PROJECT ADDRESS
Old Grain Store, Swallowfield Road, Arborfield, RG2 9LA

PROJECT DESCRIPTION
Barn Conversion

CLIENT
Mr. Nigel Clyde
TITLE
Elevations - Proposed GA

SIZE
A1
REFERENCE
MAB-C4903-480

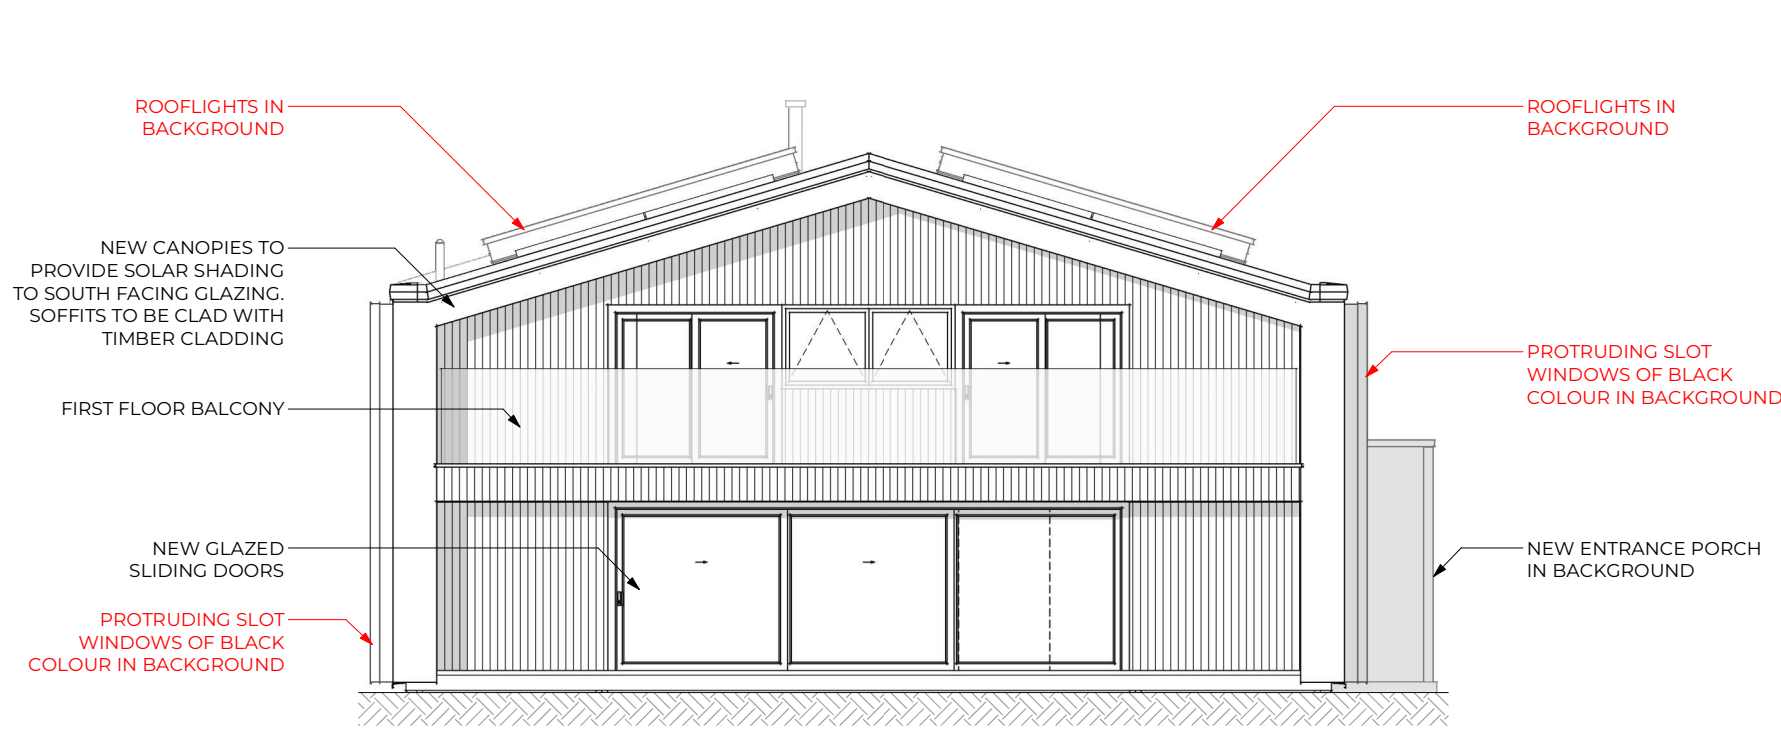
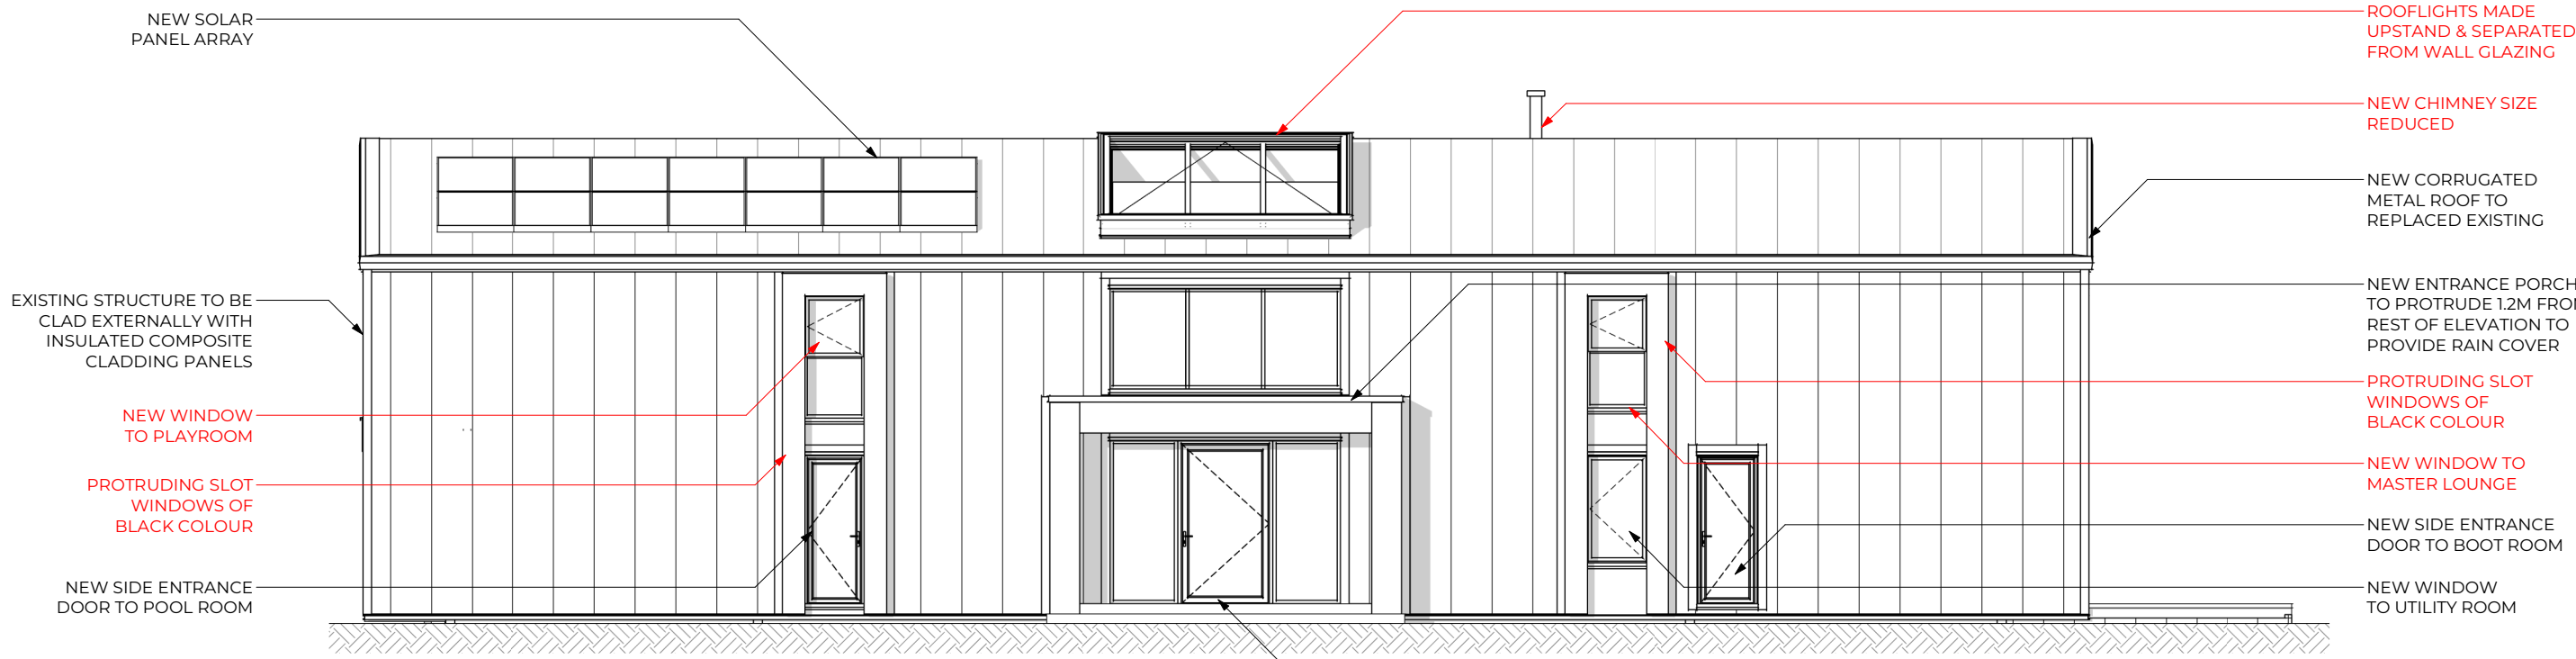
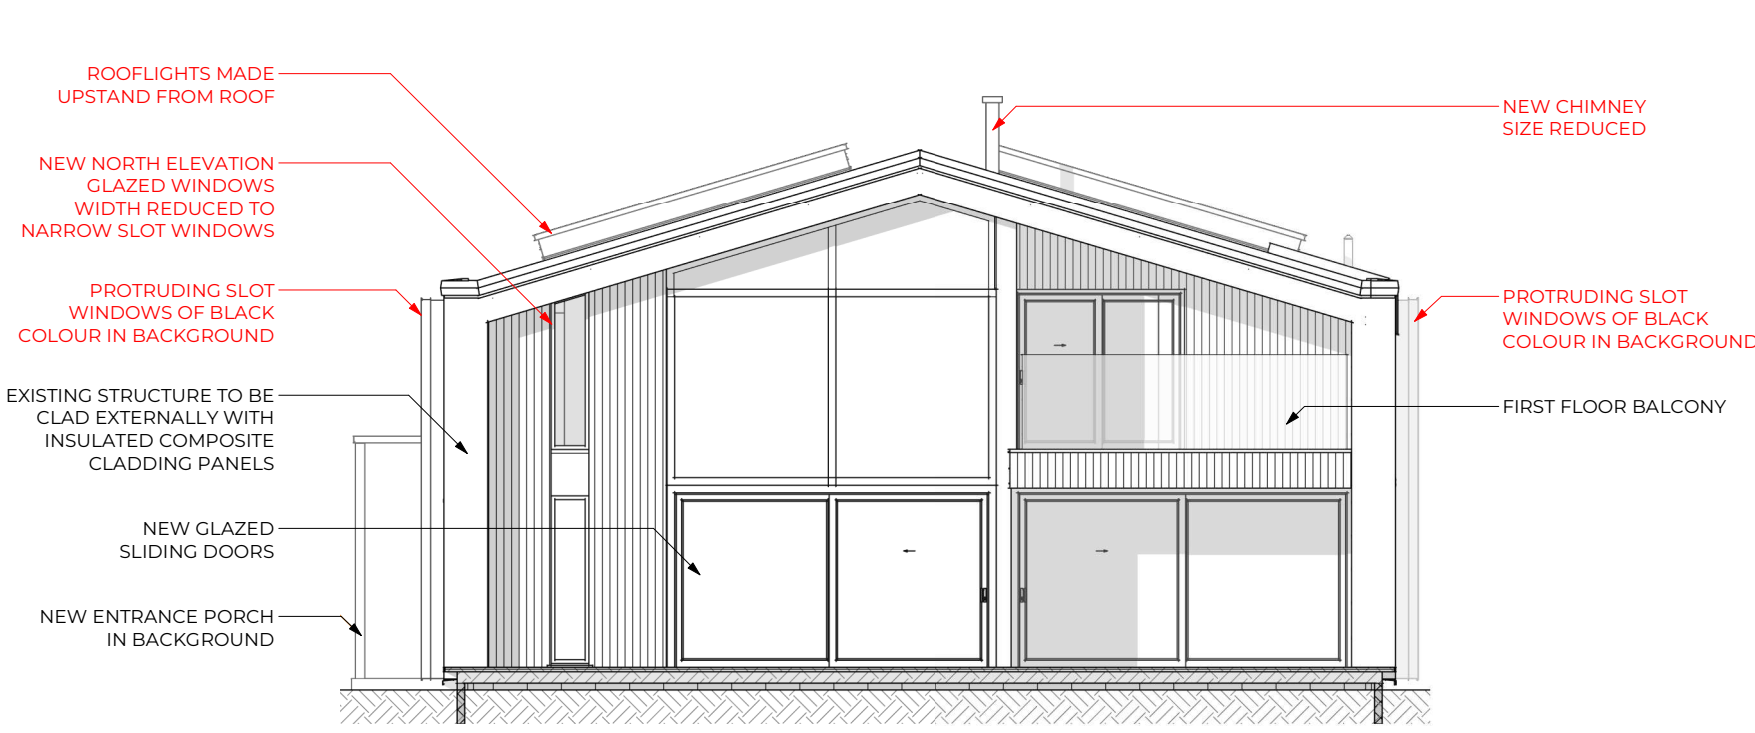
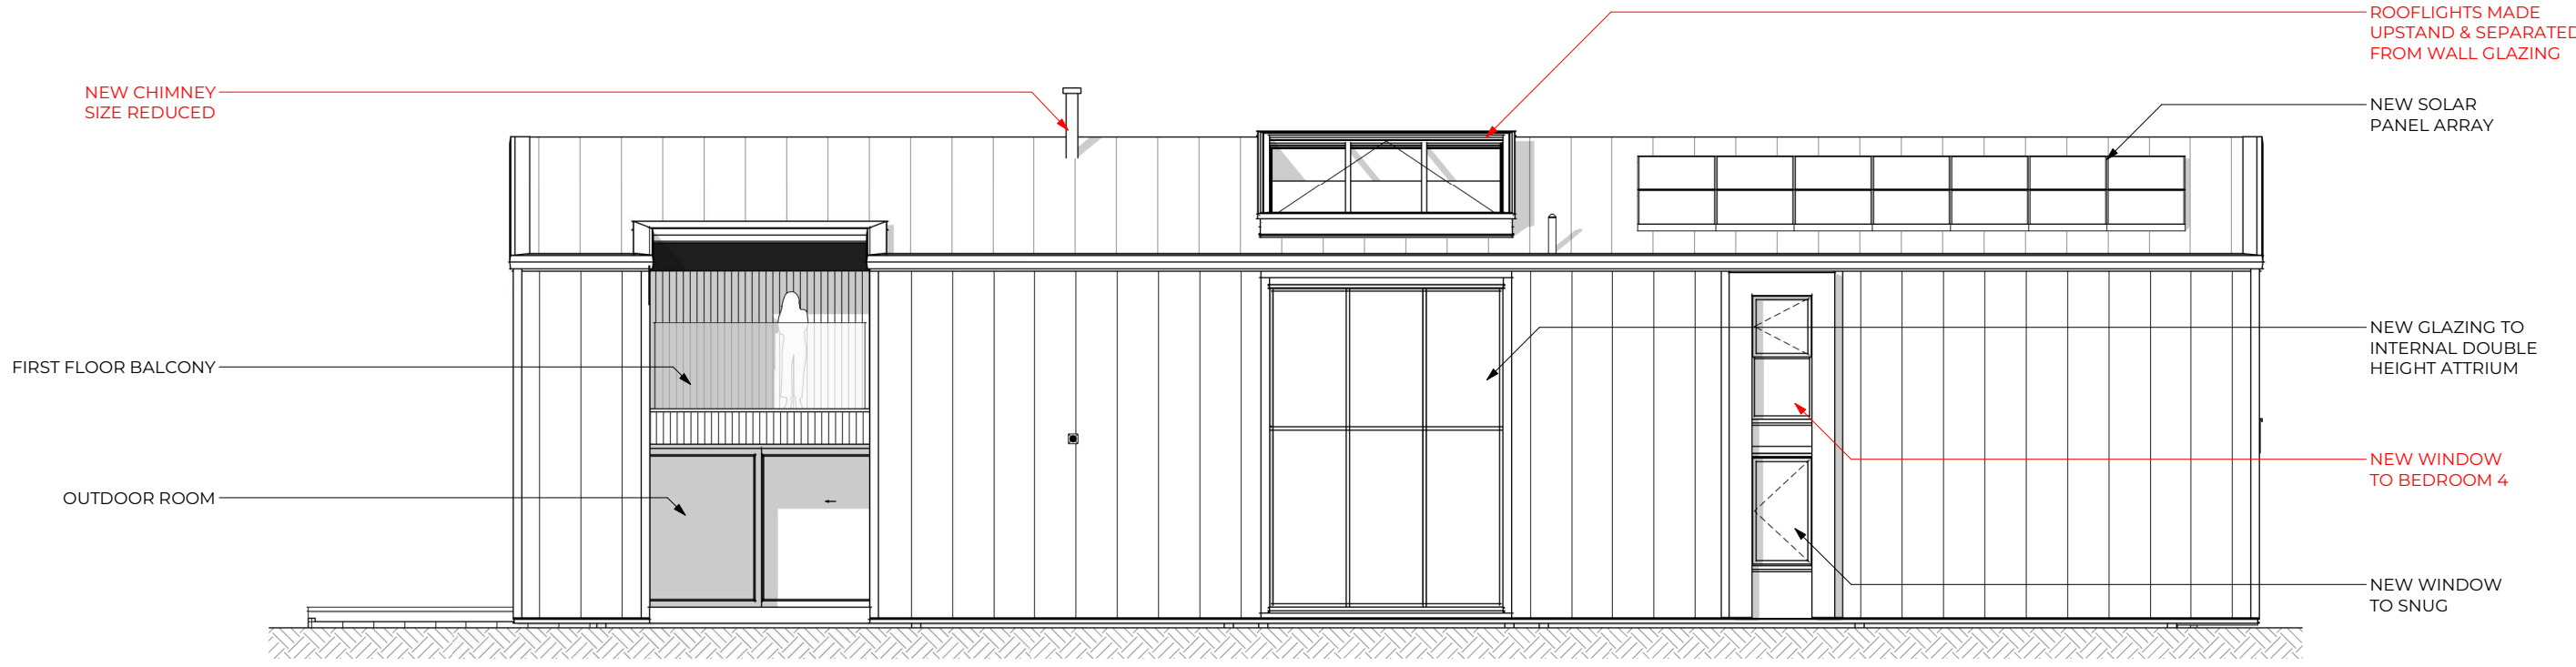
- Changes affecting elevations are noted in red and include:
- Small internal layout (larder replaced with shower; playroom swapped with bedroom 4)
 - Small rooflights to first floor rooms removed
 - Protruding two storey slot windows of black colour added to east and west elevations
 - New window to master lounge, playroom and bedroom 4 added
 - Window to pool room removed
 - Window to utility room dimensions changed
 - Rooflights made upstand & separated from wall glazing
 - North elevation glazed wall reduced to narrow slot windows
